NOD_SCE_ATJ_20211115-01

NOTICE OF DEFECT

Energy Safety Inspection Report

Report Name: SCE_ ATJ_20211115-01

Structure ID: 4194263E

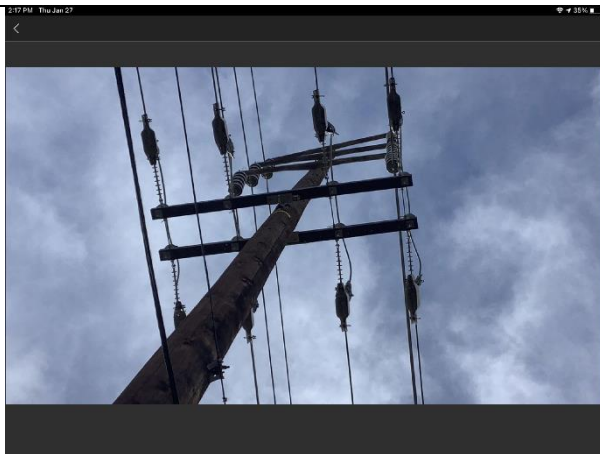
Item3IA1img1: Vibration dampers not installed

Structure ID: 1473789E

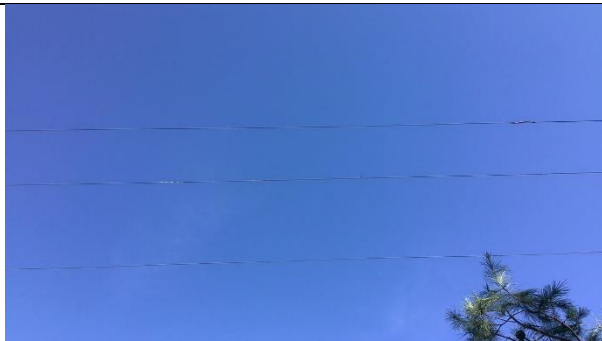
2. Defect 2: Pole numbered 1473789E had a frayed conductor strand. Broken strands weaken the tensile strength of a conductor. Therefore, a conductor with frayed strands can increase the risk of conductor failure and ignition. Energy Safety considers this defect to be in the Minor risk category.

3. Defect 3: Pole numbered 1473789E had three or more splices in a single-phase conductor. Energy Safety considers the presence of three or more splices along a single phase of conductor to be excessive and require assessment for potential corrective action. Splices are used to connect two strands of conductor. Excessive splicing is indicative of potential issues with electrical loading, physical weakening of the line, or a pattern of repeated failures. Therefore, a span with an excessive number of splices is an indicator of increased the risk of conductor failure and potential ignition. Energy Safety considers this defect to be in the Minor risk category.

Item7CD4Img1: Overall view of pole looking East containing three splices

Item7CD4Img2: Close up of frayed conductor

Item7CD4Img3: Two splices and frayed wire

Conductor Question #9 Photo

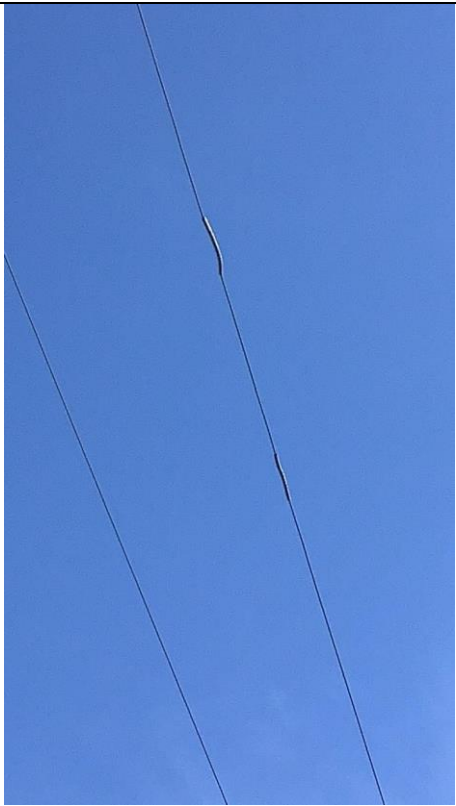
Item7CD9Img1: Two splices on one phase

Item7CD9Img2: Third splice on same phase
